SUBJECT: Forwards non-proprietary & proprietary response to 970905
 RAI re structural evaluation of proposed mod of plant spent
 fuel storage pool, dtd 970331. Proprietary response withheld,
 per 10CFR2.790.

Subject: Response to Request for Additional Information - Spent
Fuel Pool (SFP) Modifications - Structural Design
Considerations (TAC No. M95759)
R.E. Ginna Nuclear Power Plant
Docket No. 50-244

By Reference 1, the NRC staff requested additional information
regarding the proposed Modification of the Ginna Spent Fuel Storage
Pool dated March 31, 1997. The questions were related to the
Structural Evaluation of the proposed Modification.

Figure NRC01a.1Design Vs Input For GINNA SSE1 - Horizontal X

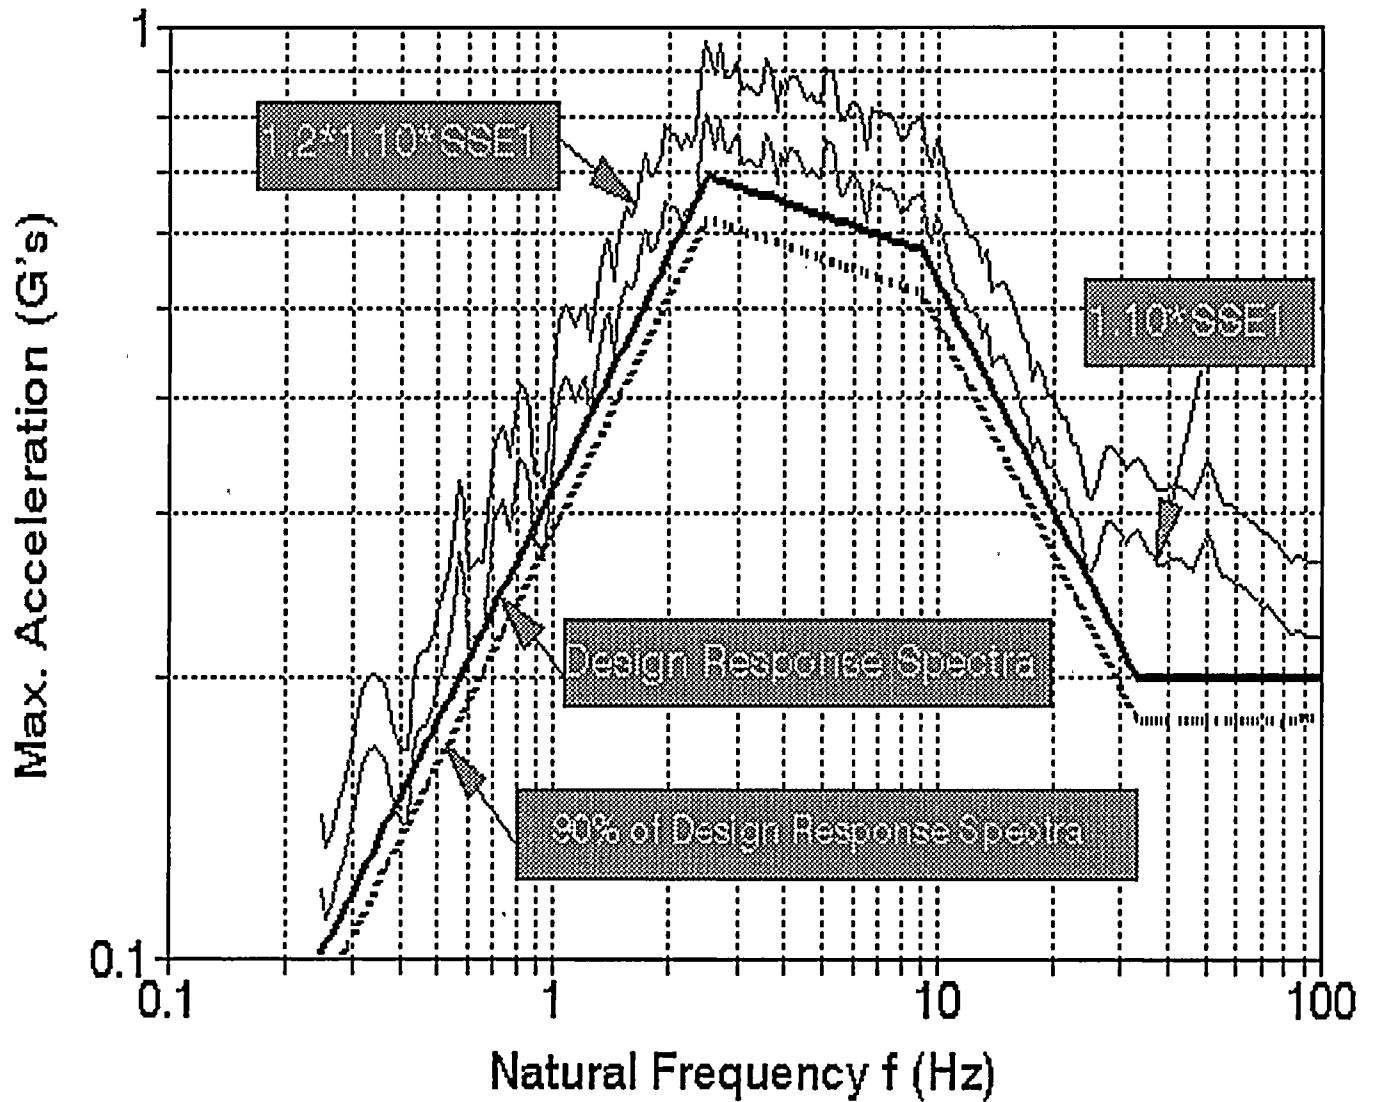
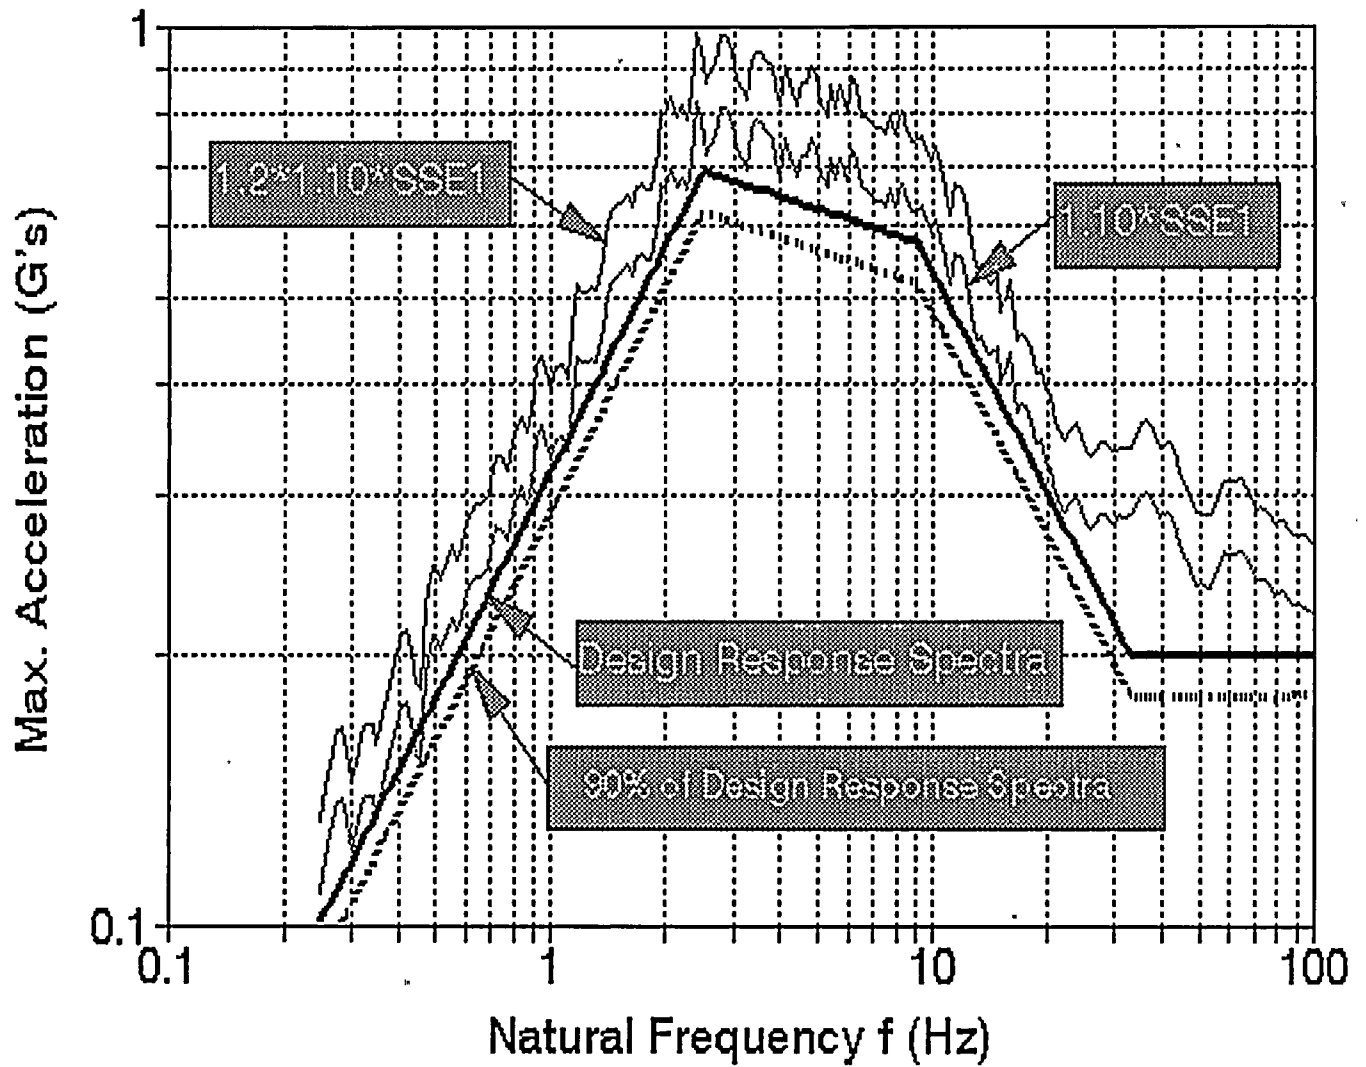
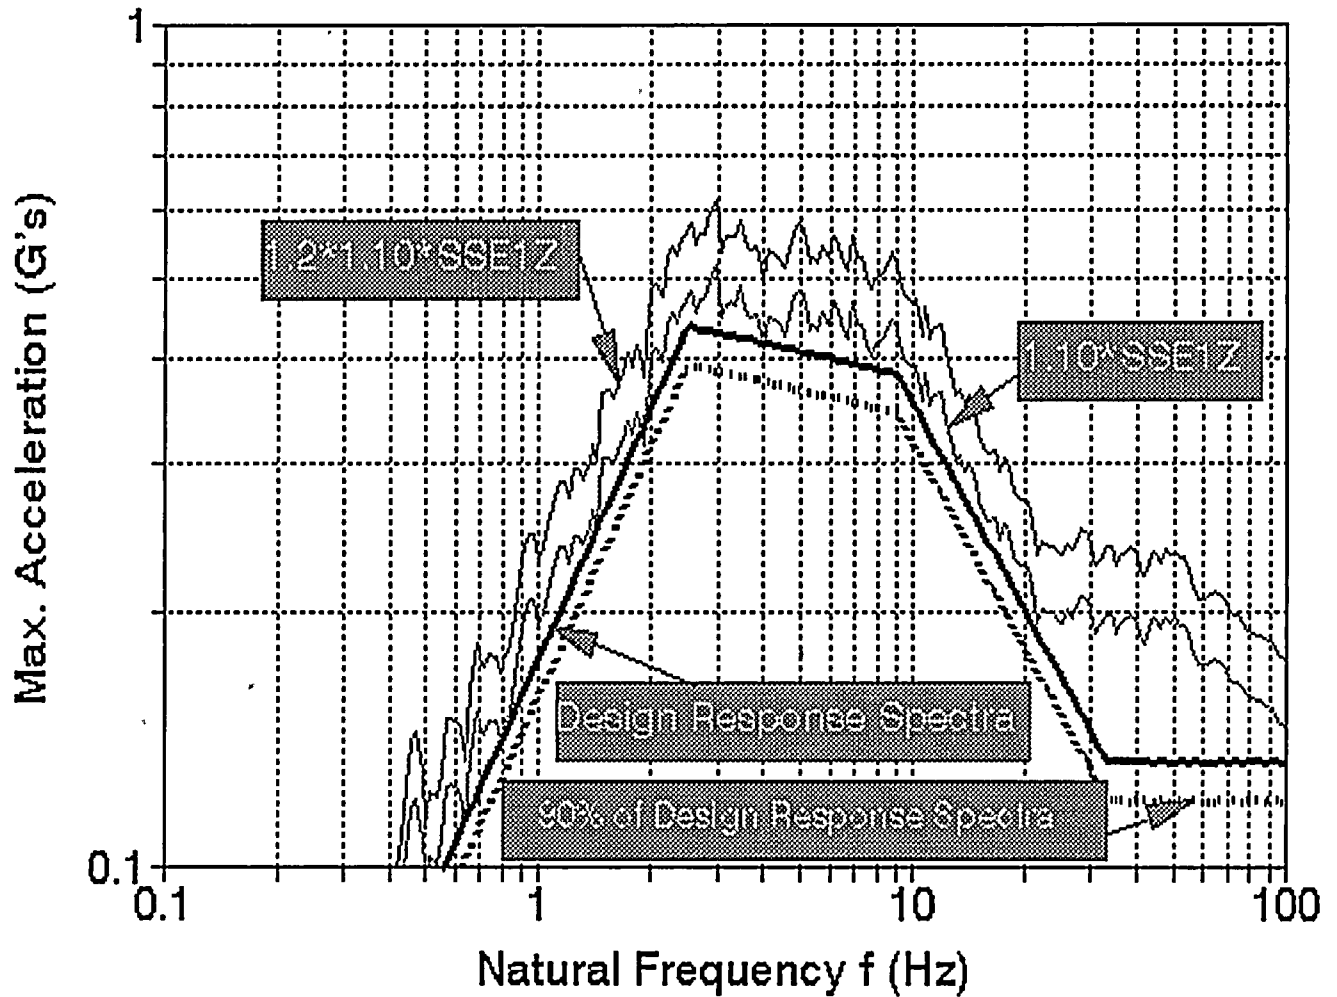
With respect to the single safe shutdown earthquake (SSE) artificial time history used for stress analysis as mentioned on page 75 of the Reference, provide the following:

- a) *A comparison between the response spectrum (RS) of the artificial time history and the licensing basis design RS in the final safety analysis report (FSAR).*
- b) *Demonstrate the adequacy of the artificial time history including a demonstration of the extent of conformance to a target power spectral density (PSD) function of the artificial time history in accordance with guidance provided in Standard Review Plan (SRP) Section 3.7.1.*
- c) *If the RS of the artificial time history does not envelope the licensing basis design RS in the FSAR, what is the basis for using it in the analysis?*

- a) A comparison of the fuel pool safe shutdown earthquake (SSE) response spectra and the response spectra generated from the SSE1 time history used in the seismic analysis is provided in Figures NRCQ1a.1, NRCQ1a.2 and NRCQ1a.3. NUREG-800, SRP 3.7.1, Section II.1.b states "Each calculated spectrum of the artificial time history is considered to envelop the design response spectrum when no more than five points fall below, and no more than 10 percent below, the design response spectrum." For this comparison, the 10% below curve is also plotted in Figures NRCQ1a.1, NRCQ1a.2 and NRCQ1a.3. The comparison shows:

East-West (X) Spectra	2 frequencies below design RS but within 10% threshold
North-South (Y) Spectra	2 frequencies below design RS but within 10% threshold
Vertical (Z) Spectra	1 frequency below design RS but within 10% threshold

Therefore, this comparison shows that the selected seismic time histories meet the requirements of SRP 3.7.1.

Figure A1 Experiment Setup

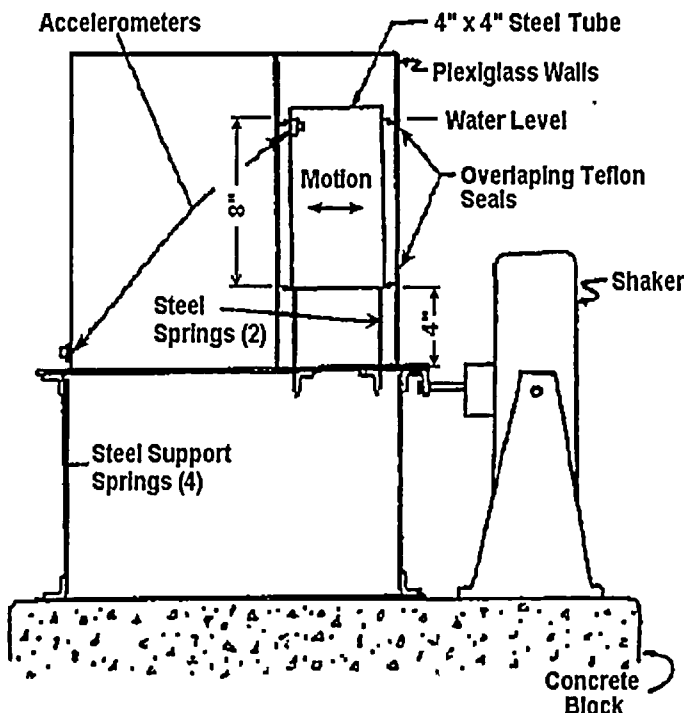
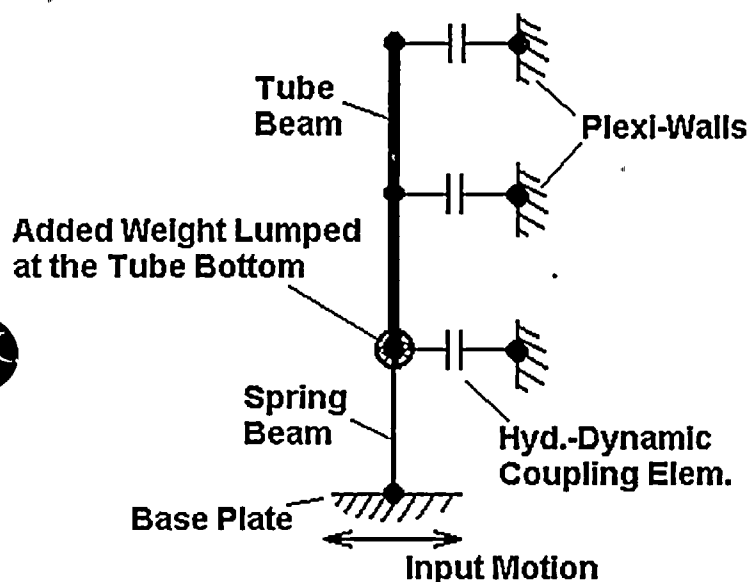
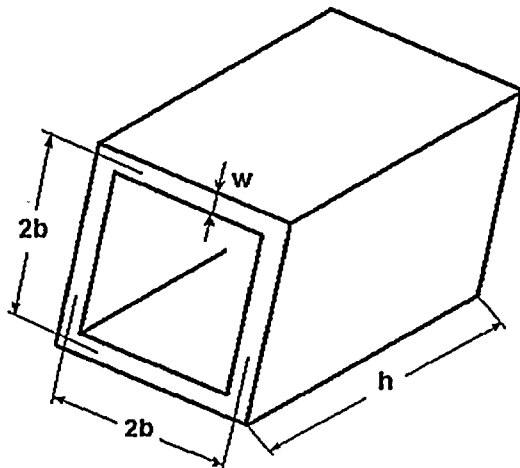
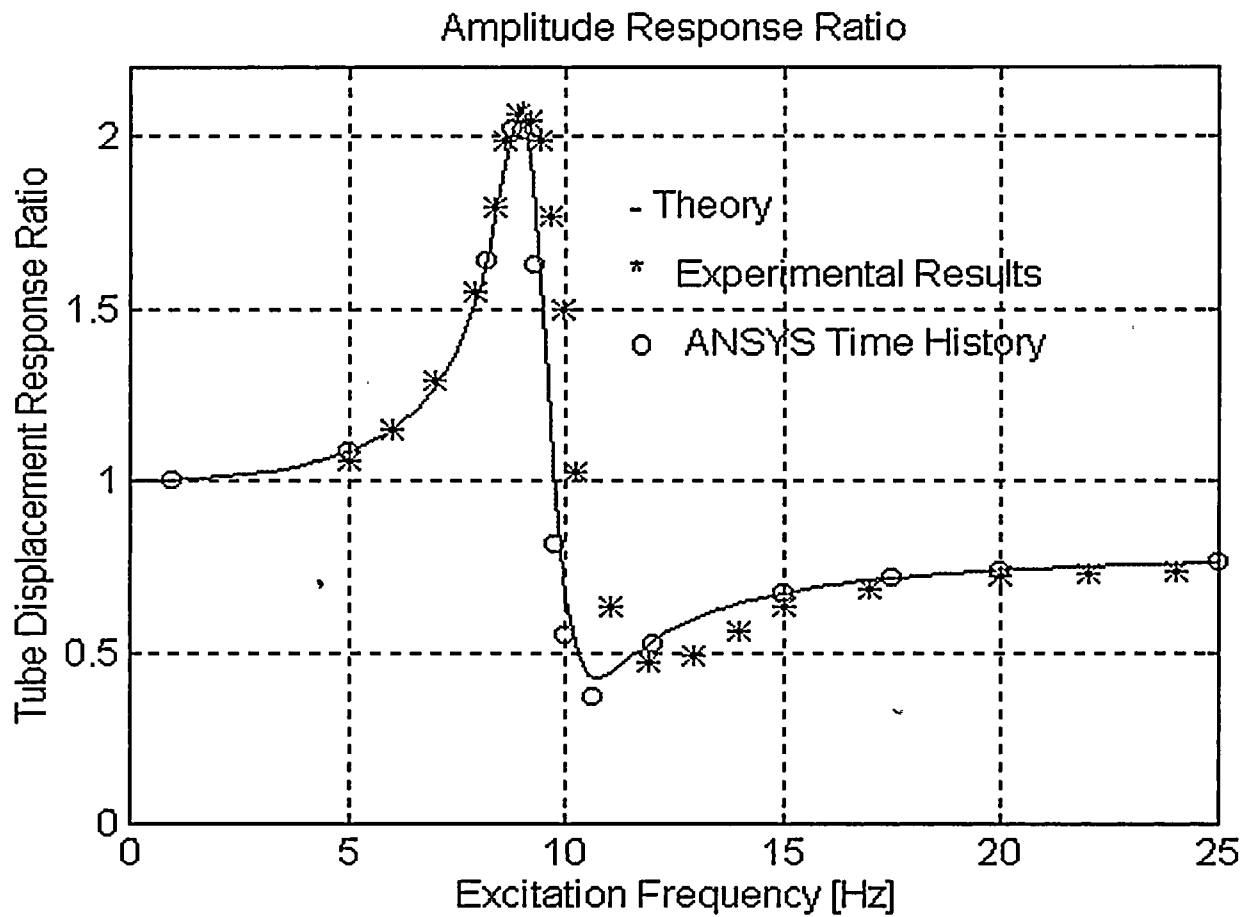
- b) *Provide the results of any existing experimental study that verifies the correct or adequate simulation of the fluid coupling utilized in the numeric analyses for the fuel assemblies, racks and walls. If there is no such experimental study available, provide in detail technical justifications on how the current level of the ANSYS code verification is adequate for engineering applications and should be accepted without further experimental verification work.*

- b) The experimental verification of the fluid coupling simulation is provided in Appendix NRCQ2-A to this question. The results show very good agreement between the ANSYS results and the experimental test results.

An ANSYS numerical study was made to demonstrate the correlation between an ANSYS model utilizing hydrodynamically coupled rectangular tube contained within a laterally excited rectangular container, or cavity, and the experimental results reported in References 3.45 and 3.46. A single degree-of-freedom (DOF) oscillator model (Ref. 3.45), used for estimating certain system's parameters is also compared to the ANSYS results.

The experiment (in water) data points are obtained from Ref. 3.46. Note that the accuracy of their coordinates in amplitude response plot (Fig.A4) might be insufficient, due to the small scale of the original experiment curve provided in Ref. 3.45. However, their trend is sufficient to validate the ANSYS model's comparison. In the time history method, a 3 second displacement time history is created for each selected excitation frequency, and applied at the selected nodes of the system. The amplitude for all time-histories is unity, i.e., 1.0 in. ANSYS results are also compared against single DOF oscillator model (equation 24 in Ref. 3.45, labeled as "Theory" in Fig. A4), with the total tube mass lumped at the top of the spring beam. Figure A4 shows good comparison between the ANSYS and theoretical response ratio predictions. A minor discrepancy between these models and the experiment is in part due to a sensitivity of measuring equipment, as suggested in Ref. 3.46.

- 1) It is concluded that ANSYS hydrodynamic element FLUID38 can be used to represent fluid-structure interaction of rectangular prismatic containers with good correlation with both theory and test results. There is a good agreement between ANSYS results and experimental test data for dynamic fluid-structure interaction problems. This verifies the capacity of ANSYS to perform seismic time-history analyses of submerged spent fuel storage racks in pools.
- 2) Use of beam stick-model and lumped masses is a realistic representation of fuel and rack type structures for use in time-history driven dynamic analyses.
